Technical Bulletin

BCH020

TB0062

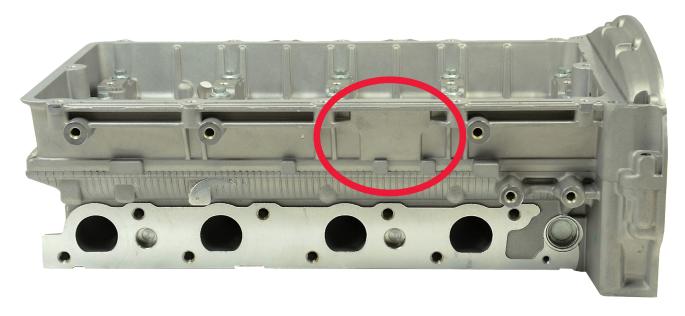
Older Ford heads had a hole in the area shown in the circle below, which was needed for the oil feed to the centrifugal oil filter. Ford eventually stopped production of the filter so the hole was no longer needed.

If your engine has the old centrifugal system, you can use the FAI BCH020 cylinder head. If using this, you will need to remove the oil pipe from the block and seal the hole in the block using the Ford plug, Finis No. 1512462.
